OLYMPIC DAM EXPANSION PROJECT

ENVIRONMENTAL IMPACT STATEMENT

S U P P L E M E N T

October 1997

Infrastructure associated with bores GAB30–32

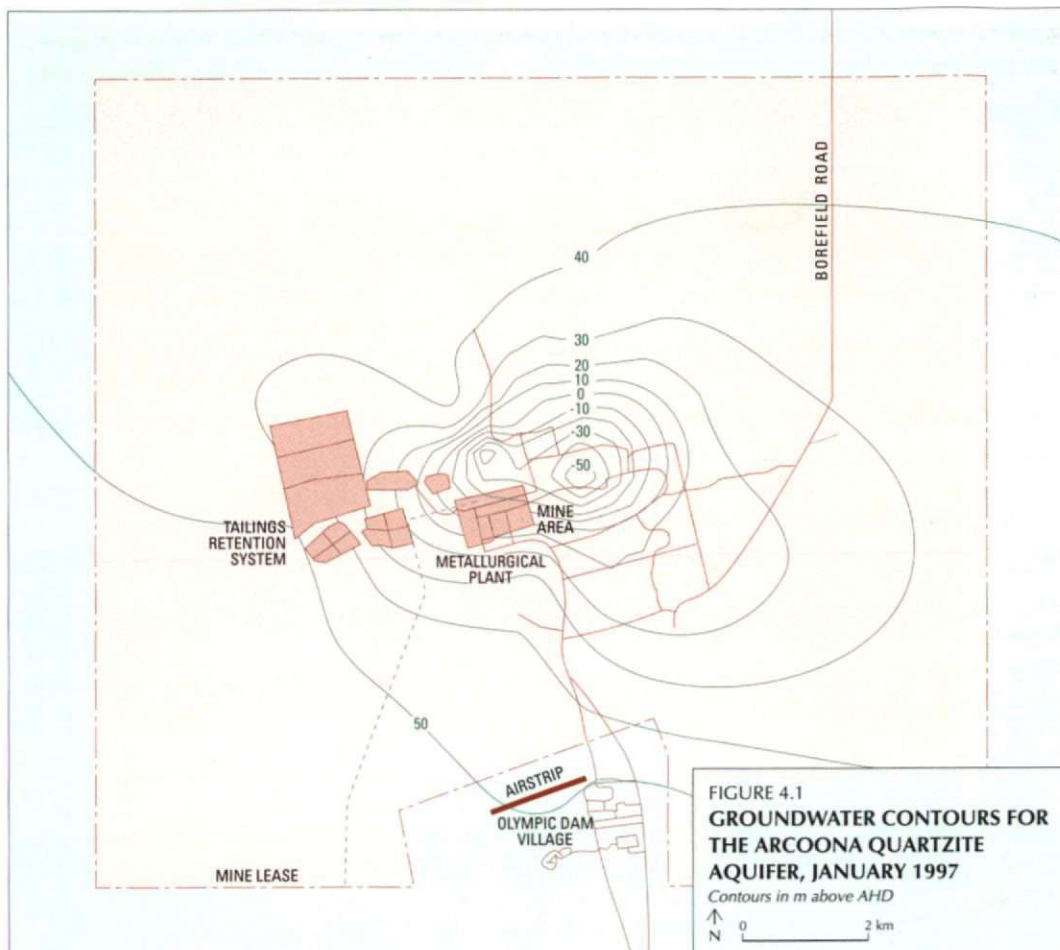
Submission P29 refers to the infrastructure associated with the now unused bores GAB30–32, considering it unsightly and likely to offend tourists who visit the area.

It is proposed that this infrastructure be removed; however, the bores themselves would remain.

FIGURE 4.2
RESULTS OF AQUIFER
REINJECTION PROGRAMME
AT BOPEECHEE SPRING

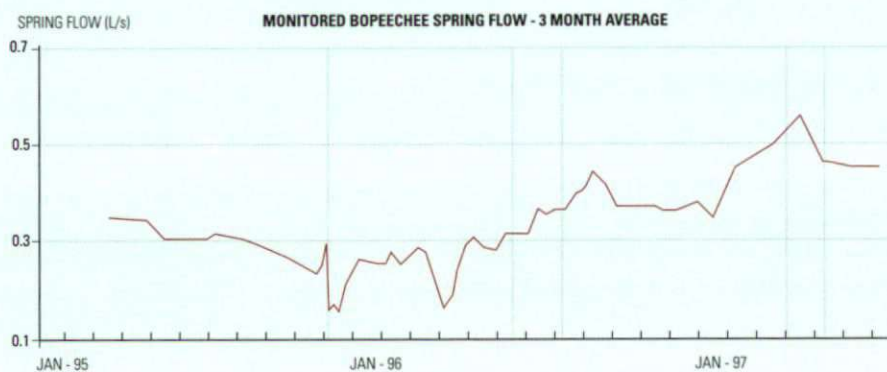
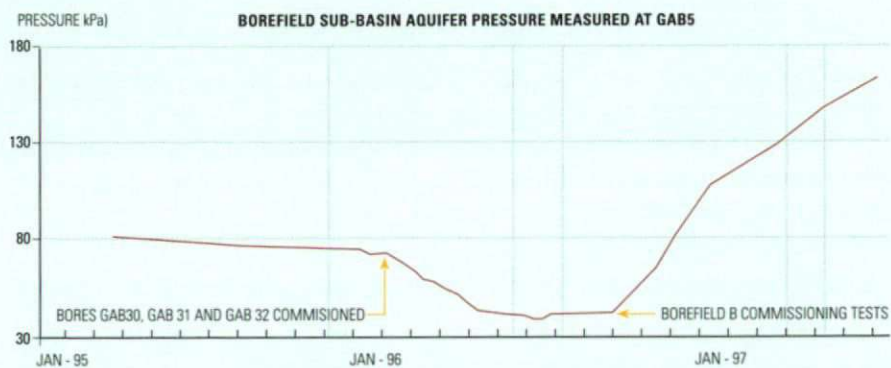
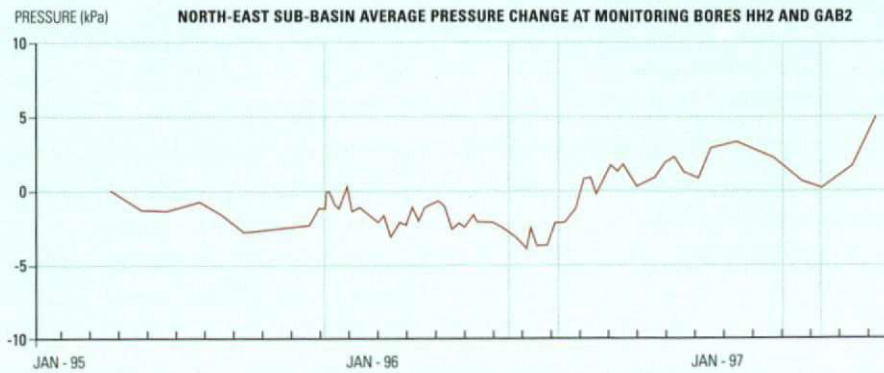
Aquifer reinjection at Bopeechee Spring

Reinjection was commenced in late October 1995 at a rate of 200 kL/d (Figure 4.2 of this Supplement). Reinjection resulted in a rapid pressure rise, averaging 2–3 kPa at monitor bores GAB8 and HH2, as shown in Figure 4.2. The reinjection rate was maintained at about 200 kL/d for most of the period November 1995 to April 1996.

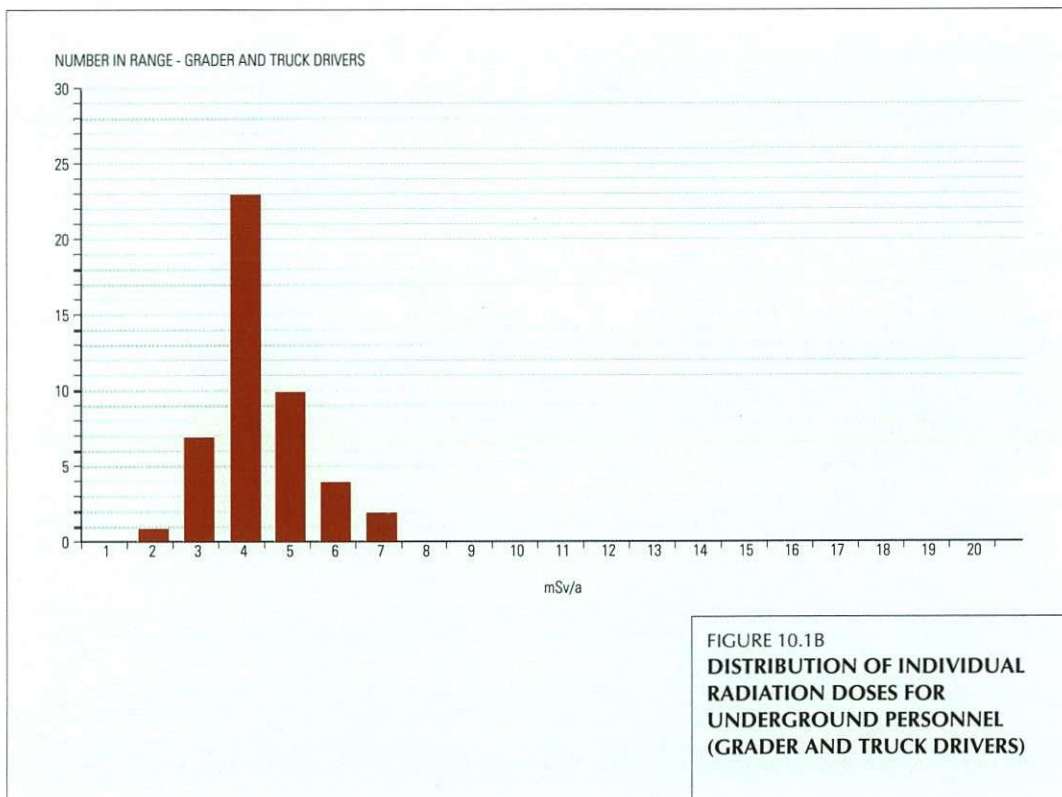
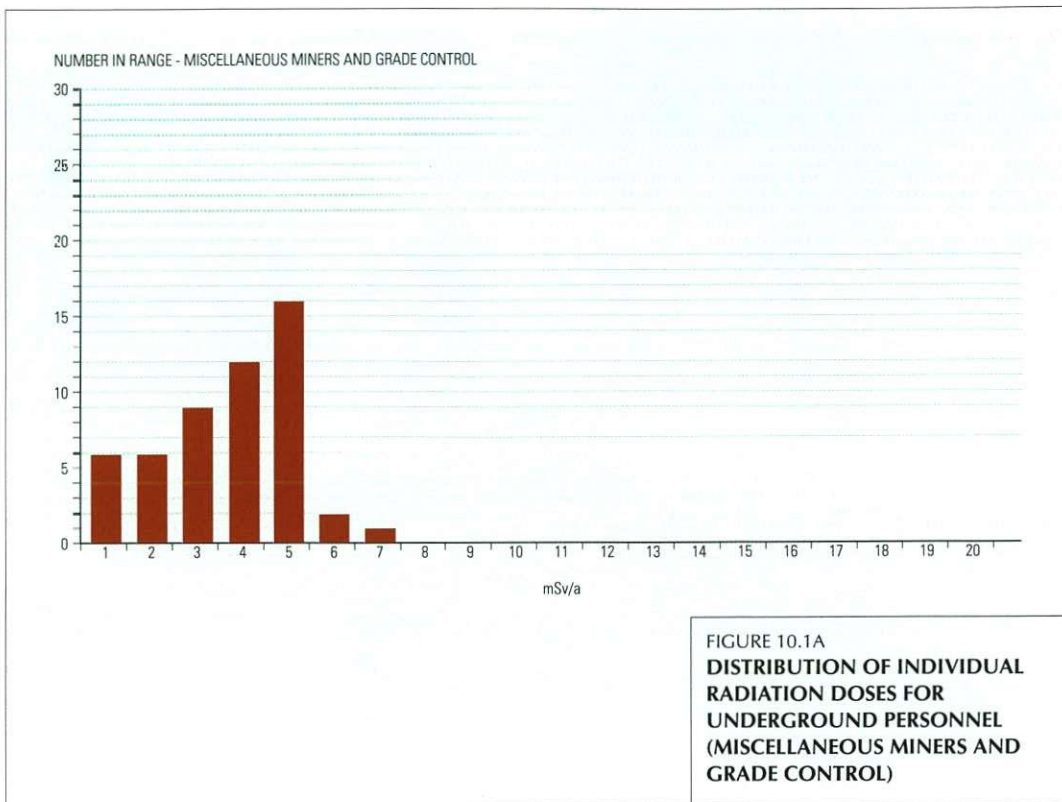
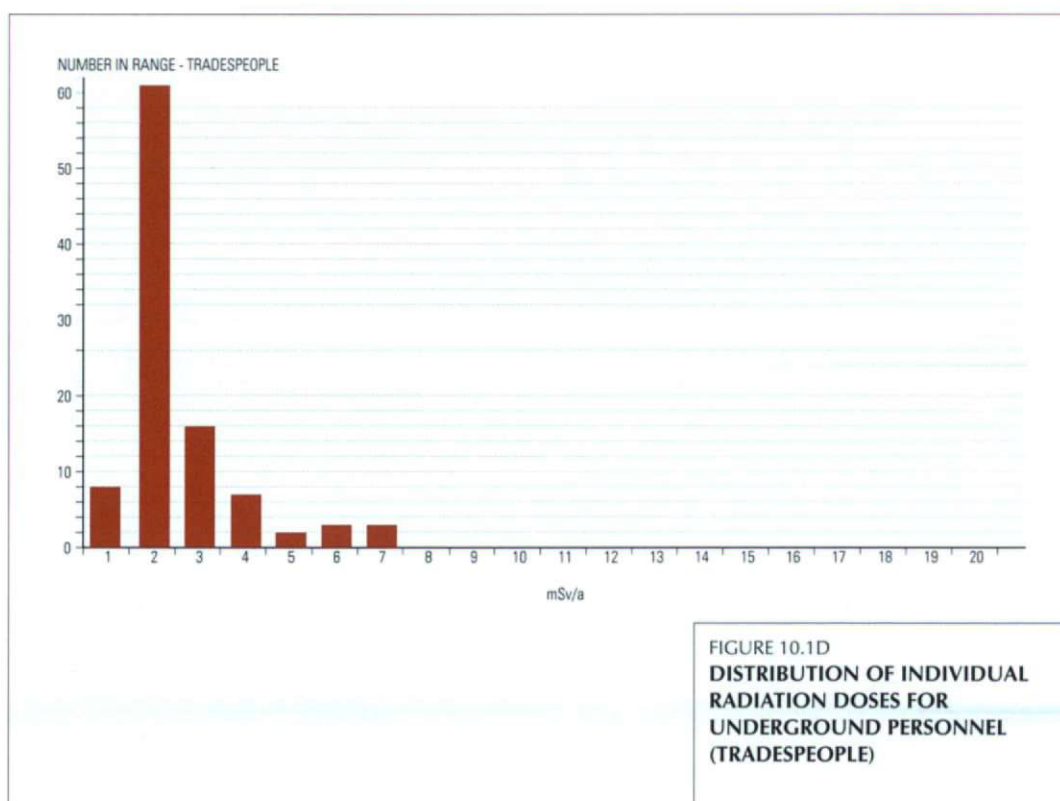
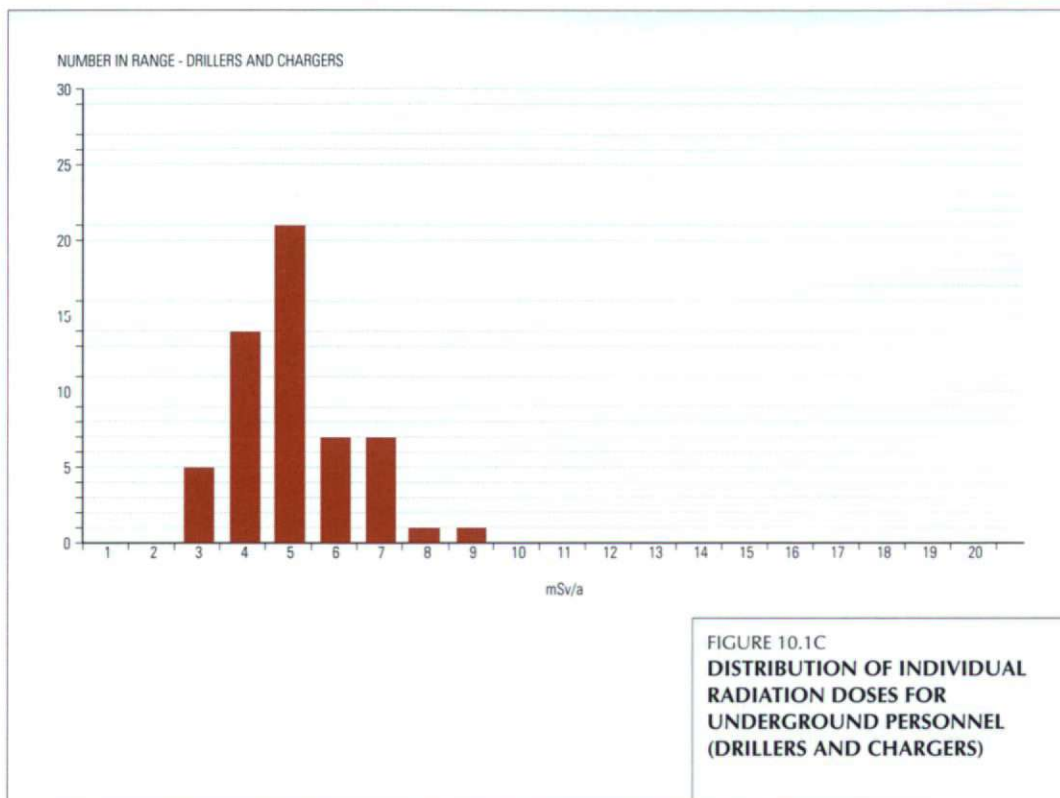
P3.78	Details of construction plans and programmes and a detailed waste management programme should also be included in the EIS.	8.10	8.3
P3.79	The EIS should contain data and figures showing the distribution of individual doses for the various occupations in the mine, processing plant and administration (c.f. Figure 10-15).	10	10.2
P3.80	Data on radionuclide composition of ventilation air and comparison with natural (pre-exploration) air should be provided.	10.2	10.2
P3.81	The EIS should respond to criticisms by Worksafe Australia regarding radiation doses from radon decay products; in particular, criticism to the effect that the proponent has underestimated, by a factor of two, radiation doses from radon decay products.	10	10.2
P3.82	The EIS should outline all the procedures for reducing radiation exposures in the area of the current smelter and calciner and the planned smelter and calciner.	10.2	10.2

Figures 10.1A, 10.1B, 10.1C and 10.1D of this Supplement show the distribution of individual radiation doses for personnel working underground. The dose distribution for personnel working above ground is shown in the EIS (Figure 10.15).

FIGURE 10.2
HIGH VOLUME AIR SAMPLER
RESULTS 1995-1996

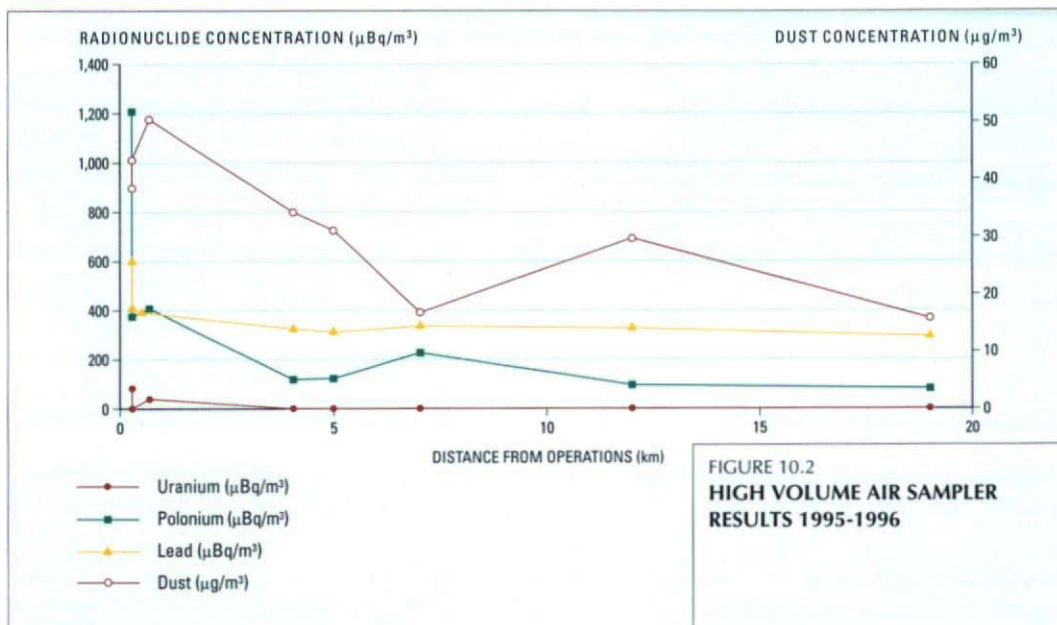
Dust concentrations (Figure 10.24)

Submission P19 asks that information on other radionuclides (in addition to the uranium shown in Figure 10.24 of the Expansion Project EIS) be shown.

The information in Figure 10.24 is incorrect and has been revised as shown in Figure 10.2 of this Supplement. The units for dust and uranium are concentrations in air. In response to a request in Submission P19 (Section 10.4 of this Supplement), information on polonium and lead has also been included. The results shown in Figure 10.2 of this Supplement support the EIS conclusions that the mine operations are undetectable beyond a distance of approximately 5 km.

Figure 10.2 of this Supplement shows data for uranium, polonium and lead, measured on high volume air sampler filters, at various distances from the site.

FIGURE 10.3a
ERROR BAR ON MEMBER OF THE
PUBLIC DOSE ASSESSMENTS—
OLYMPIC DAM VILLAGE

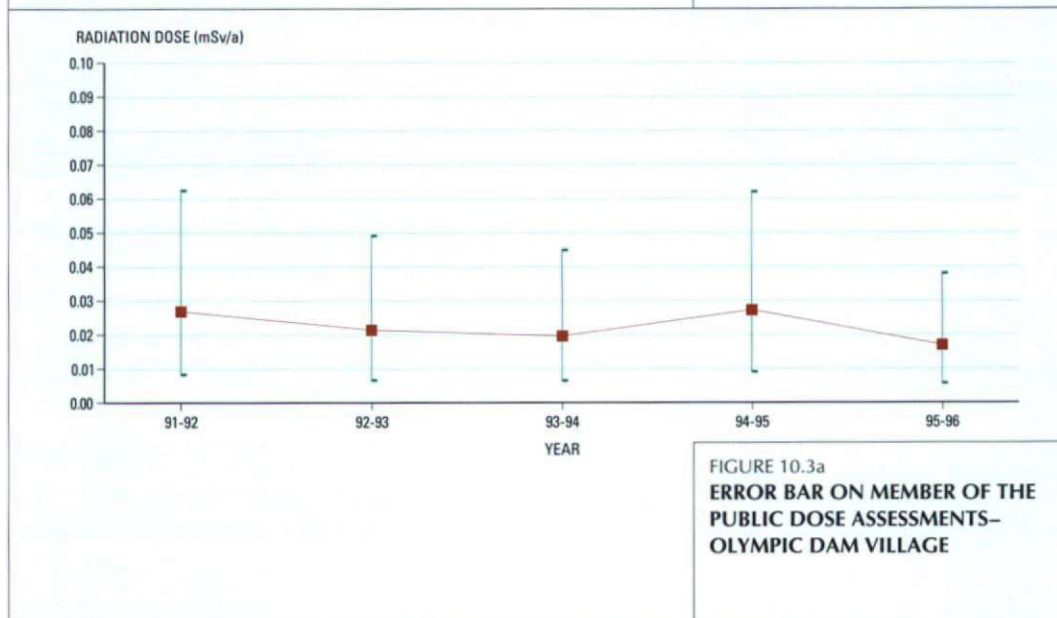
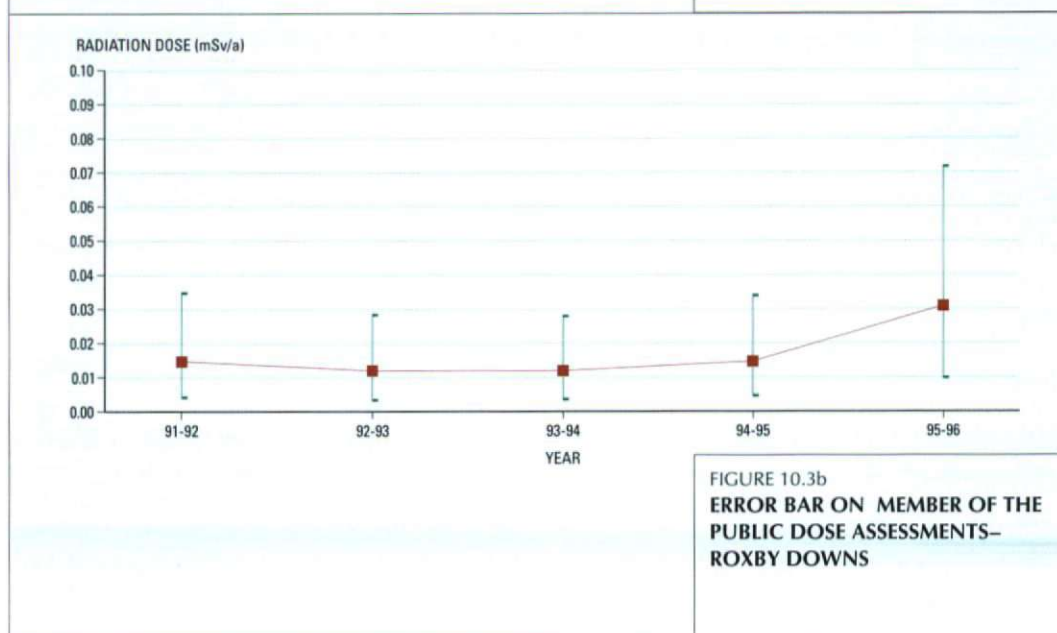
P3.90	All data on dust dispersion should include background references and contain measures of spread and uncertainty.	10.3	10.2
P3.91	There are inconsistencies in dose rate data presented in Figure 10.30 and Table 10.30. Data should be checked to make sure it is presented correctly.	10.3	10.2
P3.92	There is no measure of reliability for the claim that radiation dose is not correlated with mine production.	10.3	10.2
P3.93	Details in regard to measurements of background and pre-operational radiation levels are lacking. The year and method of determination of the so-called 'background' and 'pre-operational' uranium concentration levels should be included in the EIS.	10.3	10.2
P3.94	The EIS should discuss the difference in time between peak uranium concentrations at the Axehead and Olympic dams. The difference should be discussed in terms of mining activity, weather and the leak in the tailings retention system.	10.3	10.2

Figure 10.3 of this Supplement shows the measure of uncertainty associated with the average annual effective dose equivalent to people living full time in Olympic Dam Village and Roxby Downs.

FIGURE 10.5
COMPOSITION OF AIRBORNE
RADIONUCLIDES IN AREAS OF
THE PROCESSING PLANT

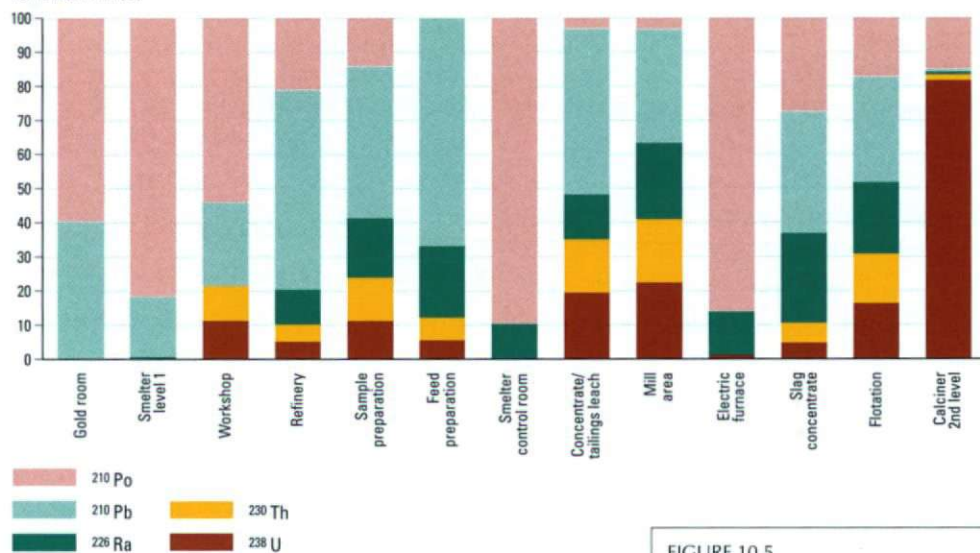
Submission P19 queries the data shown in Figure 10.8 of the EIS.

P19.10	In Figure 10.8 the ratio of airborne radionuclides appears to be incorrect. In the text there is mention of the importance of ^{210}Po in the smelter yet there is no contribution of this radionuclide to workers on Smelter level 1. This figure should be checked for correctness for all work areas.	10.2	10.4
P19.11	In Figure 10.11 it appears that the contribution of alpha-emitting radionuclides to workers in the uranium product packer is relatively small. Is a Respiratory Protection Factor (RPF) being used in the calculation of occupational exposures to airborne radionuclides.	10.2	10.4
P19.12	The numbers quoted in Table 10.3 are only the extrapolated probable occurrence of death in the defined population. The table gives the impression that this will be an actual number when it is only the probability and having 0.04 deaths is a meaningless concept (a person is either dead or alive and there is no intermediate state).	10.2	10.4

Figure 10.8 is reproduced here in its correct form and is Figure 10.5 of this Supplement.
